**CONSENT DECREE AND ORDER FOR
INJUNCTIVE RELIEF FOR
INJUNCTIVE RELIEF, DAMAGES, AND
ATTORNEY FEES, LITIGATION
EXPENSES, AND COSTS**

EXHIBIT A

**RE: Fandee's Restaurant: 7824 Covert Lane, Sebastopol, CA
Inspected by a CASp**

Fig B

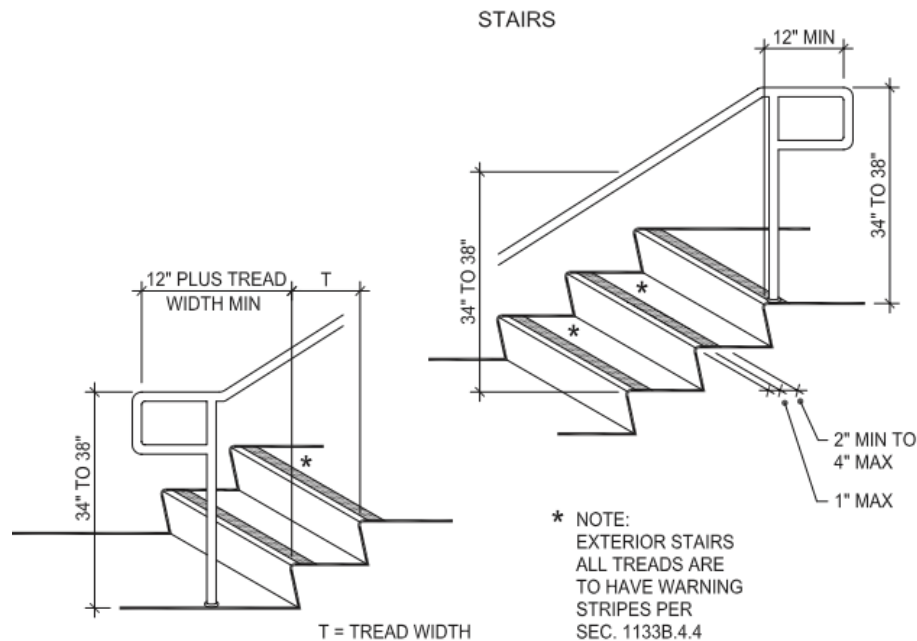
- The stairway (previous Fig 1.1) does not have contrast striping. ***Provide contrast striping on each exterior stair tread (see details below).***

The stripe shall be a minimum of 2 inches (51 mm) wide to a maximum of 4 inches (102 mm) wide placed parallel to, and not more than 1 inch (25 mm) from, the nose of the step or upper approach. The stripe shall extend the full width of the step or upper approach and shall be of material that is at least as slip resistant as the other treads of the stair. A painted stripe shall be acceptable. Grooves shall not be used to satisfy this requirement.

Fig F

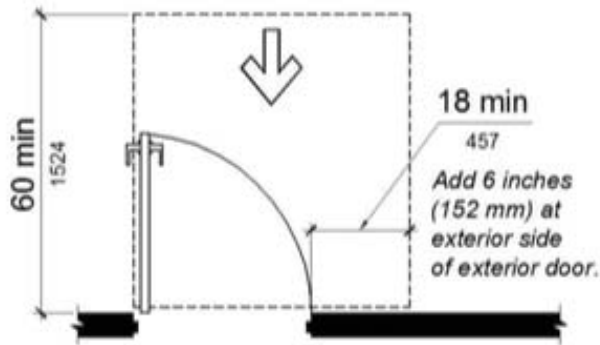
- The pull side landing has a slope of 7% in the direction of travel (Fig 2.2). *Modify and provide a 60" deep landing on the pull side of the entry door with a slope of 2% or less in any direction (see Fig F for detail). Note: a powered door opening device will mitigate the issue;*

Fig G

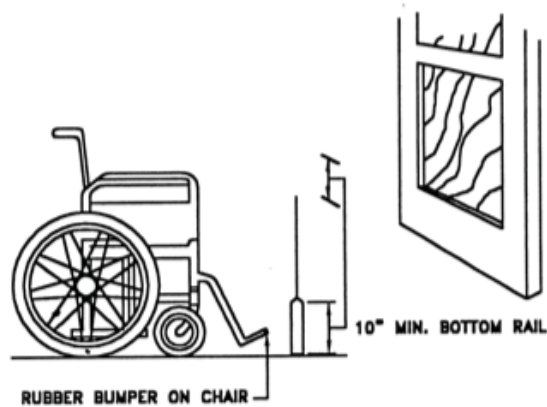
- The entry door does not have a 10" smooth bottom surface (previous Fig 2.2). **Modify and provide a 10" high smooth and uninterrupted bottom surface on the push side of the entry door (see Fig G for detail). Note: a powered door opening device will mitigate the issue;**

- The gate does not have a 10" smooth bottom surface (Fig 2.9). *Modify and provide a 10" high smooth and uninterrupted bottom surface on the push side of the gate (see previous Fig G for detail);*

Fig H – Height Requirements

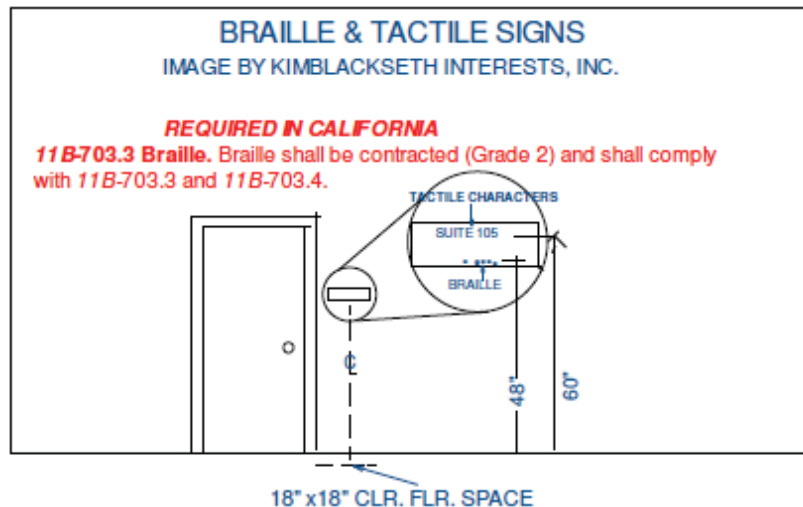
- The exit doors (Fig 2.3 below) do not have the tactile and Braille exit sign. **Modify and provide the tactile and contracted Grade 2 Braille sign at all exits and mount as described below and in Fig H. Note: CA Braille spacing is required and shown below (Fig I below), as it differs from the Federal standards;**

11B-703.4.2 Location - Where a tactile sign is provided at a door, the sign shall be located alongside the door at the latch side. Where a tactile sign is provided at double doors with one active leaf, the sign shall be located on the inactive leaf. Where a tactile sign is provided at double doors with two active leafs, the sign shall be located to the right of the right-hand door. Where there is no wall space at the latch side of a single door or at the right side of double doors, signs shall be located on the nearest adjacent wall. Signs containing tactile characters shall be located so that a clear floor space of 18 inches (457 mm) minimum by 18 inches (457 mm) minimum, centered on the tactile characters, is provided beyond the arc of any door swing between the closed position and 45-degree open position. Where permanent identification signage is provided for rooms and spaces they shall be located on the approach side of the door as one enters the room or space. Signs that identify exits shall be located on the approach side of the door as one exits the room or space.

Fig I – CBC Spacing Requirements

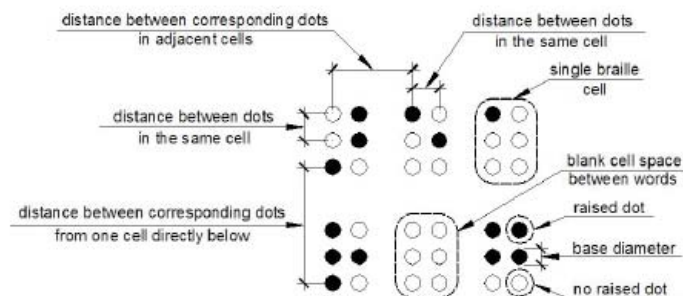
- The required wall sign is not provided. The sign on the door has incorrect Braille spacing. *Provide a wall sign with contracted Grade 2 Braille with CA spacing (see previous Fig I for Braille spacing requirements);*

Fig J

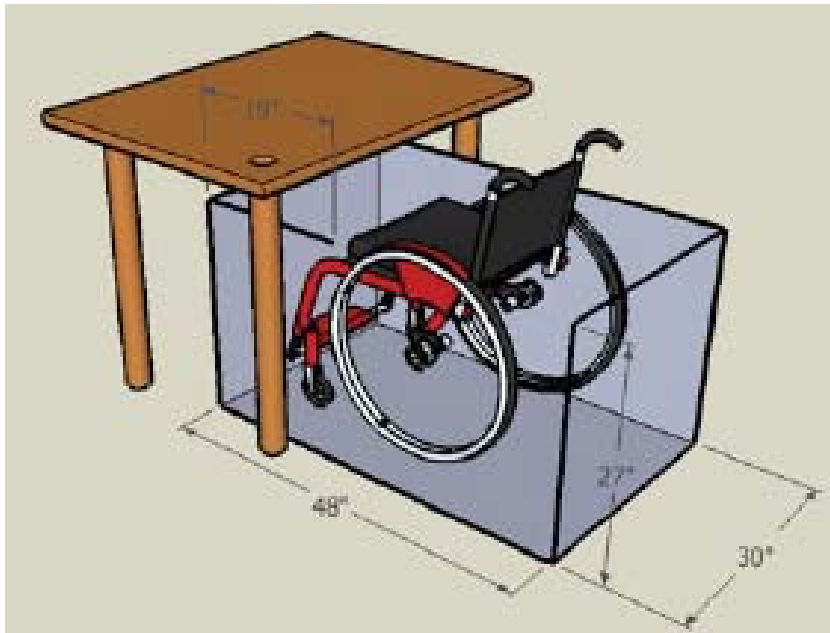
- There are approximately 58 total seating spaces (tables and booths) and there are no accessible tables due to the table base (Fig 2.4) or booth seating. 5% of seating spaces are required to be accessible. *Modify and provide 5% of seating spaces with knee and toe clearance illustrated in Fig J below;*

- There are approximately 20 total seating spaces in the patio area and there are no accessible tables due to the table base (Fig 3.2). 5% of seating spaces are required to be accessible. *Modify and provide 5% of seating spaces with knee and toe clearance illustrated in Fig J above;*

Fig K

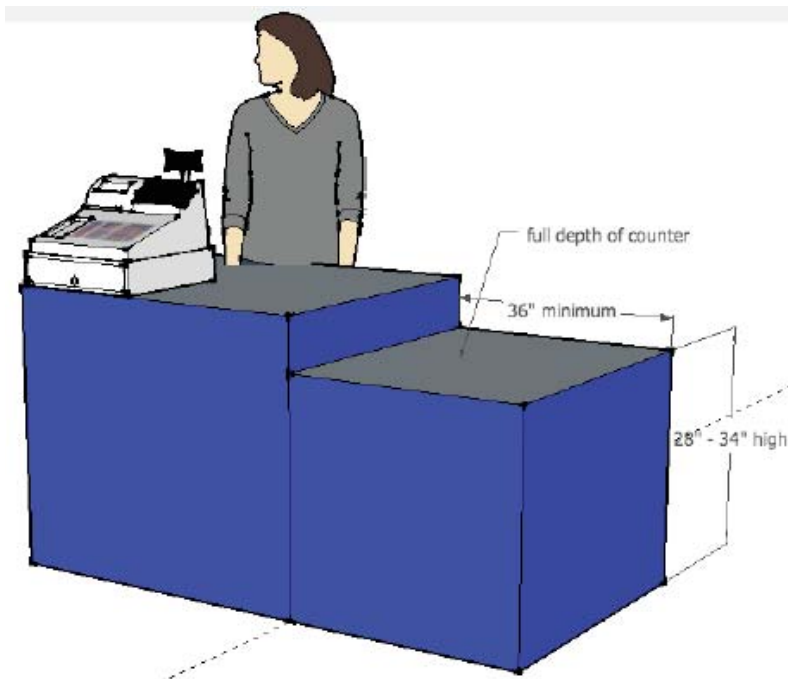
- The main counter is 42" high (Fig 2.5). If transactions occur at the counter (for to go orders) a lowered transaction counter will be required. ***Provide a lowered counter 34" high maximum above the floor by a minimum of 36" long (see Fig K below for detail);***

Fig L

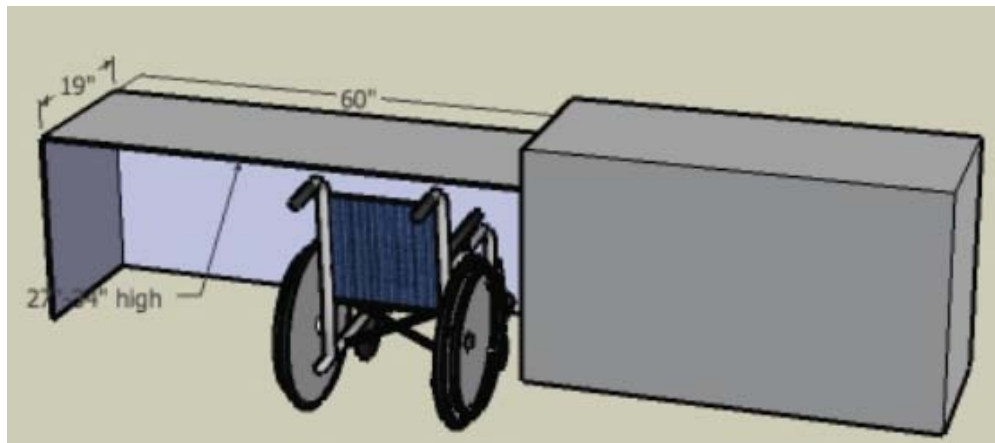
- The dining counter is 37" high (Fig 2.6). *Modify and provide a lowered dining counter 34" high by a minimum of 60" long and 19" deep minimum, if counter was built in the 2011 alteration (see Fig L below for detail);*

Fig 2.7

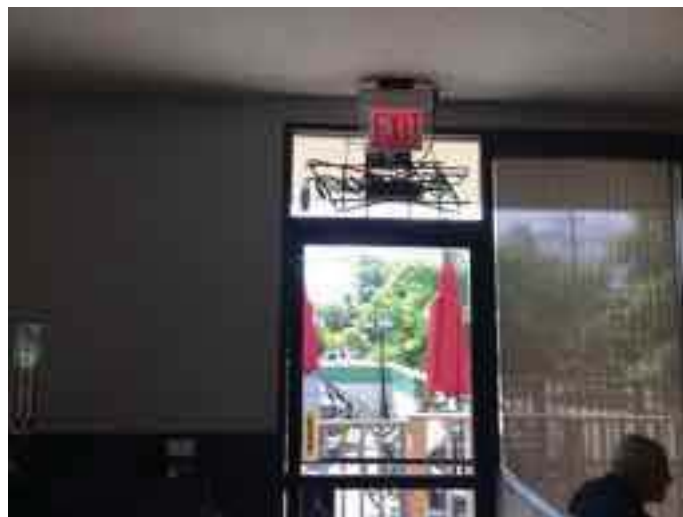
- The exit door requires 10 lbs. of effort to operate and closes within 2 seconds (Fig 2.7). *Adjust and maintain door effort to 5 lbs. or less and a closing speed of 5 seconds minimum. Note: a powered door opening device will mitigate the issue;*

Fig M

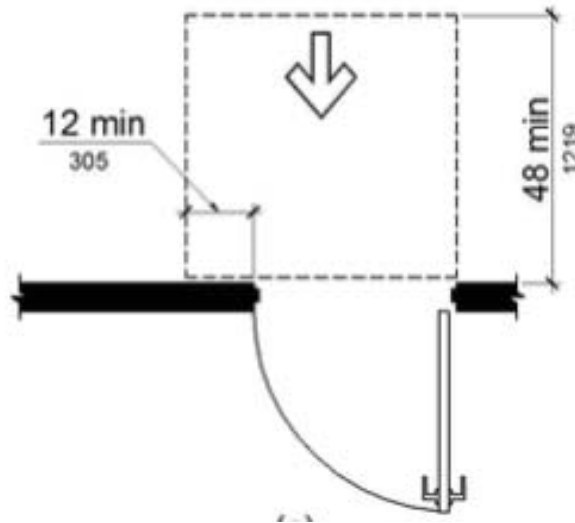
- The door leading to the restroom area has a closer and latch with only 5" of strike clearance on the push side (Fig 3.3 – minimum 12" required). *We recommend removing the closer or latch to mitigate the issue;*

Fig P

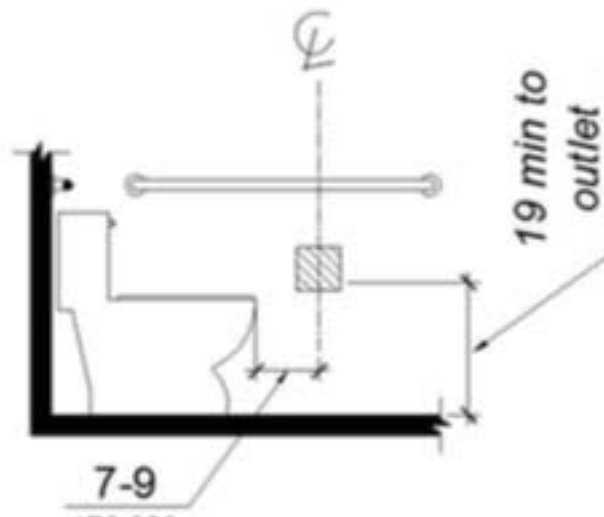
- The toilet tissue dispenser is mounted 16" above the floor (Fig 3.8).
Modify and remount toilet tissue dispenser a minimum of 19" above the floor below the side grab bar, 7" to 9" in front of the toilet (see Fig P for detail);
